# ORIGINATION FORM

Proposed Revisions to a Standard Plans Index  
(Please provide all information – Incomplete forms will be returned)

Index Number: 450-063  
Sheet Number (s): 1  
Index Title: Florida-I 63 Beam - Standard Details

ELEVATION

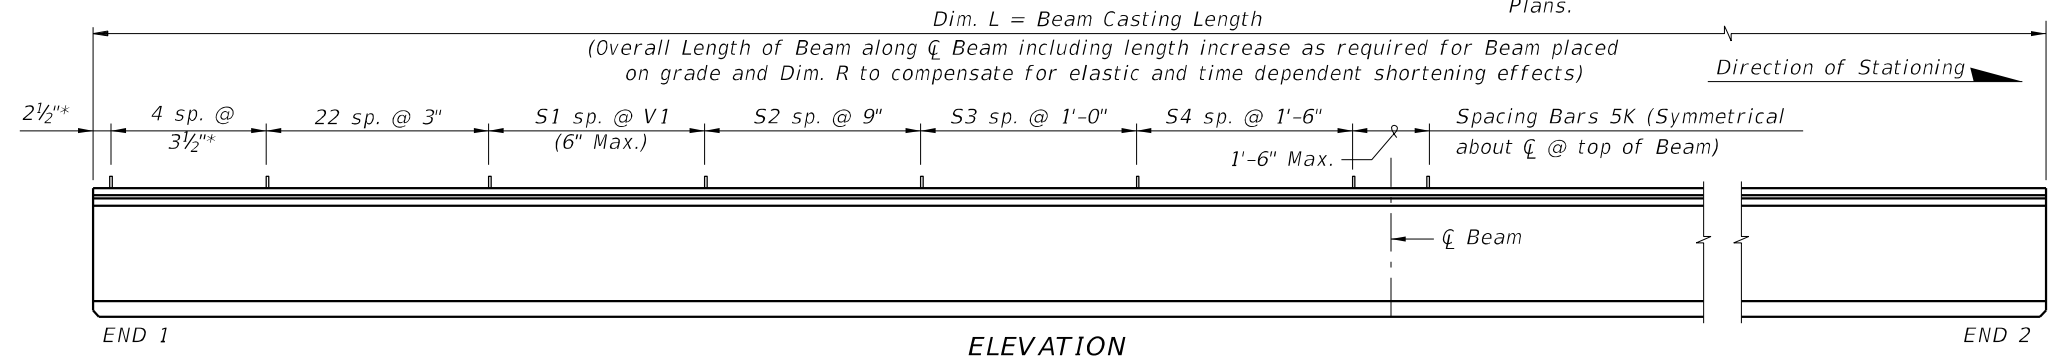
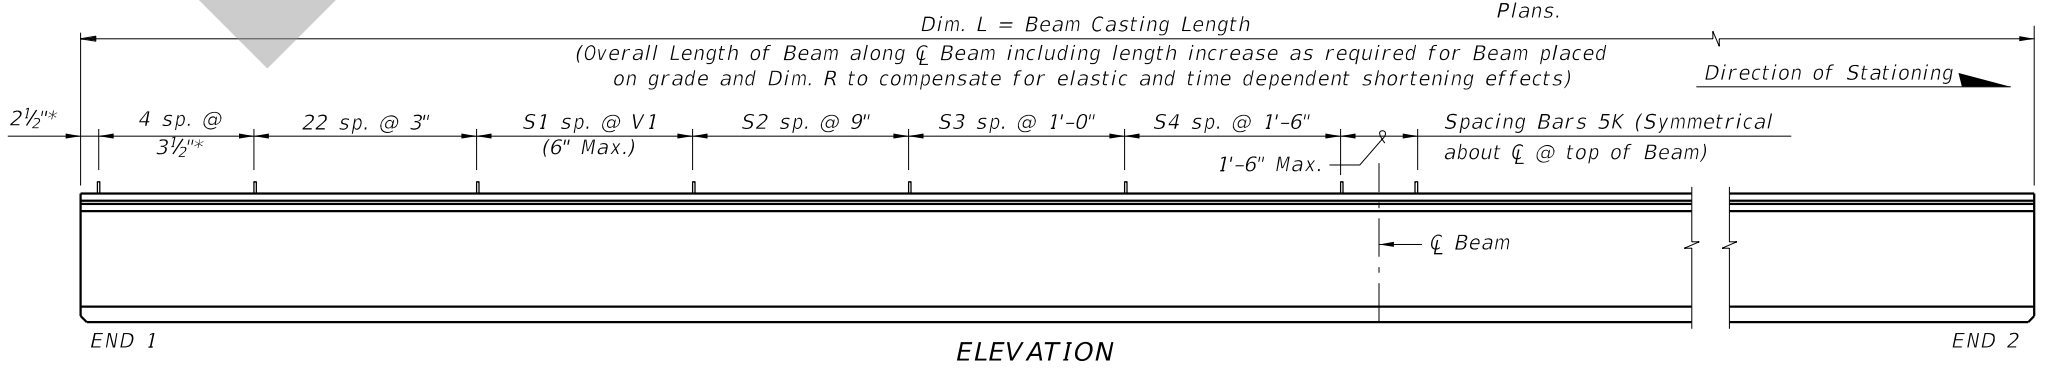
Deleted Intermediate Diaphragm Inserts

Diaphragms not required; therefore Inserts not required.
